WATER QUALITY MEMORANDUM

Utah Coal Regulatory Program

RE: 2009 2nd Quarter Water Monitoring, Canyon Fuel Company, Soldier Canyon Mine, C/007/0018 WQ09-2, Task ID #3318

TDS vs. Time

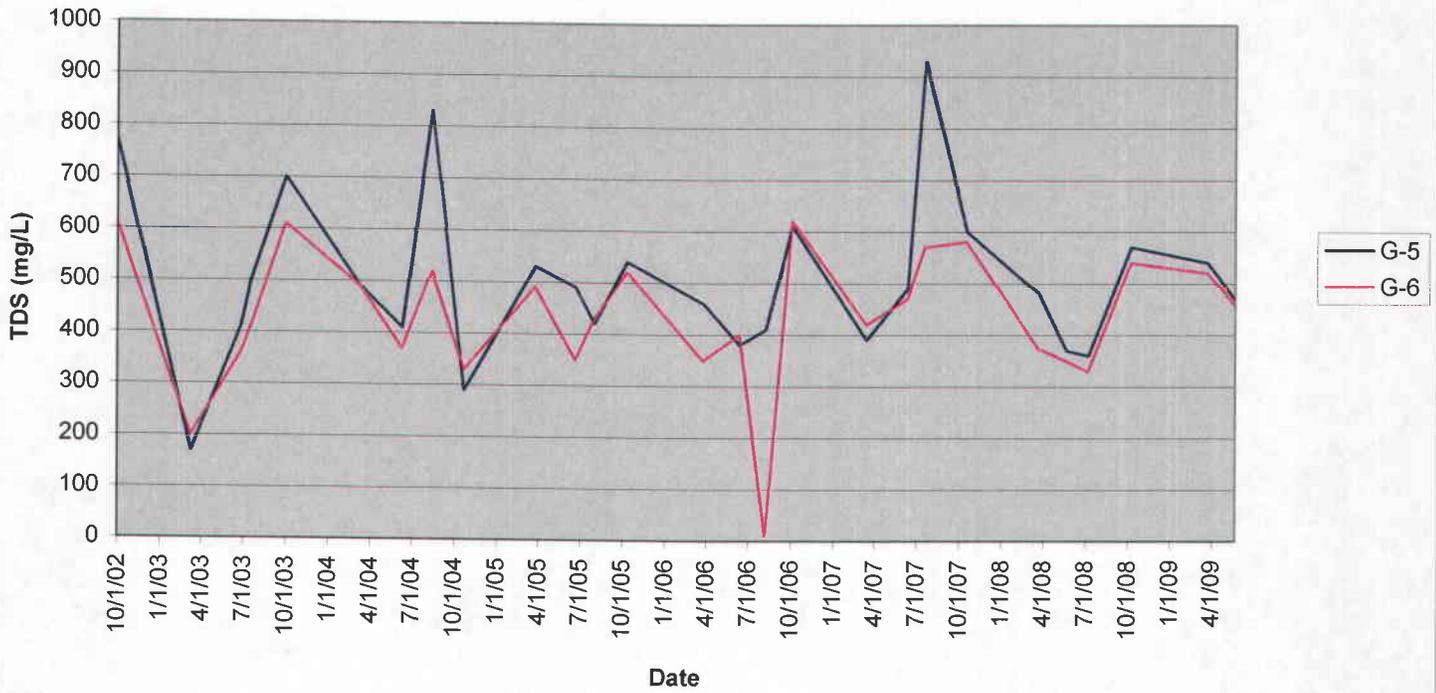
TDS values for both G-5 and G-6 continue to trend well below the 3,000-mg/L value as established by Rule R317-2 Standards of Quality for Waters of the State. For this quarter, G-5 and G-6 produced TDS levels of 460 mg/L and 470 mg/L respectively
